平陆县 100MW 农光互补光伏发电项目

监理工程师通知单

编号: ZHJL-JLTZ-PL-071

主题: 关于监理、总包对东郑光伏场区初验收检查发现以下需要消缺项:

1

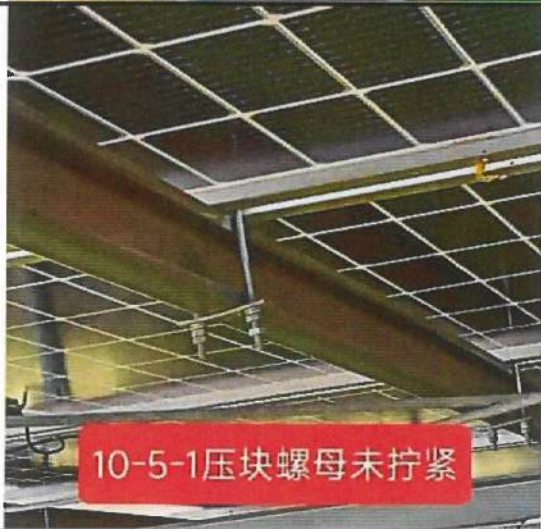
整改内容: 见下图

12

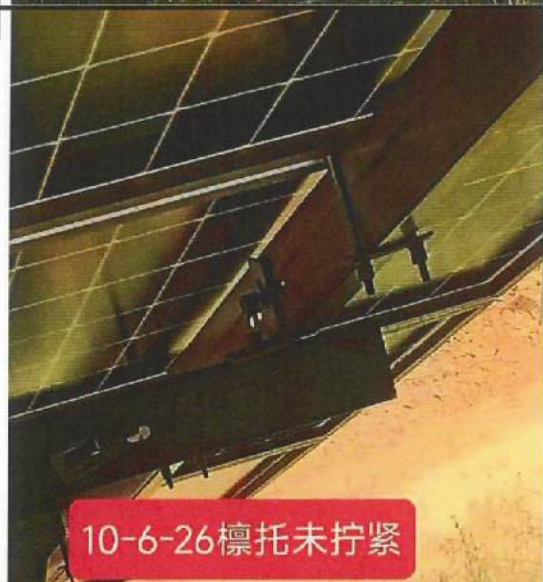
10-6-27斜撑螺栓未拧紧

10-6-27组件下有小树苗
需清理 (通病)

15

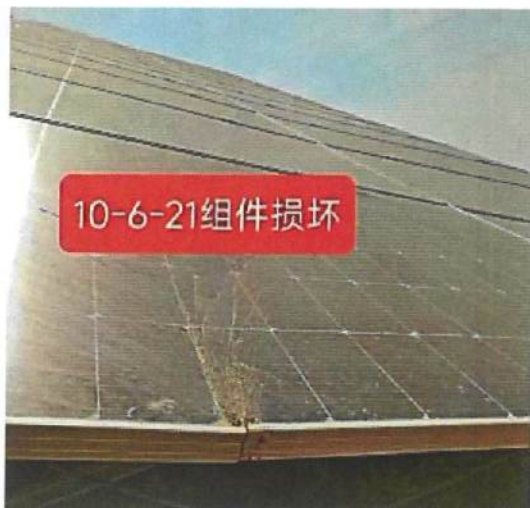
10-6-26压块缺少螺母

10-6-26檩托未拧紧

10-6-26檩托缺少平垫
(通病)
